UNITED STATES PATENT AND TRADEMARK OFFICE

Office Action Summary	Application No. 10/525,896	Applicant(s) PLUMMER, MARCUS	
	Examiner BRANON C. PAINTER	Art Unit 3633

DETAILED ACTION

Reproduced from Halls

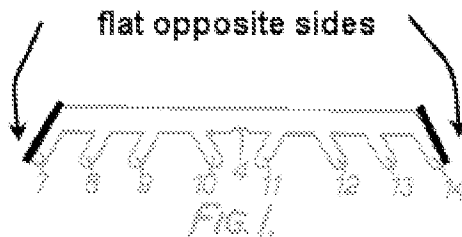
- c. The strip comprising a pre-formed line of weakness extending longitudinally along its length intermediate its opposite side edges ("notch" 4, Fig. 1).
- d. The strip being flat on opposite sides of the line in its as-formed condition (amended Fig. 1).
- e. The strip side edges being biased against the side edges of the respective adjacent panels with the strip inserted completely into the gap between panels ("the strip is resiliently deformable to a generally U-shape with the one face outermost by bending about the central longitudinal axis of the strip and to be positioned in a gap between juxtaposed surfaces," lines 28-33; Fig. 4).

5. Regarding claim 10, Halls discloses a flat strip with a line of weakness along which the strip is folded ("notch" 4, Fig. 1).
6. Regarding claim 1, Hall discloses the claimed method steps set forth in claim 1. Said steps can clearly be seen in Hall's specification and drawings.

- 16. Applicant's arguments filed 06/19/08 have been fully considered but they are not persuasive.
- 17. Applicant argues that the strip of Halls is not flat and does not have a pre-formed line of weakness. However, the strip of Halls is "flat on opposite sides of said line" as discussed above and shown in amended Fig. 1. Furthermore, the elongated notch 4 of Halls is a line of weakness and thus meets the claim limitations.
- 18. Applicant's arguments with respect to Bogle have been considered but are moot in view of the new ground(s) of rejection.
- 19. Applicant's arguments regarding floor board gap widths do not comply with 37 CFR 1.111(c) because they do not clearly point out the patentable novelty which he or she thinks the claims present in view of the state of the art disclosed by the
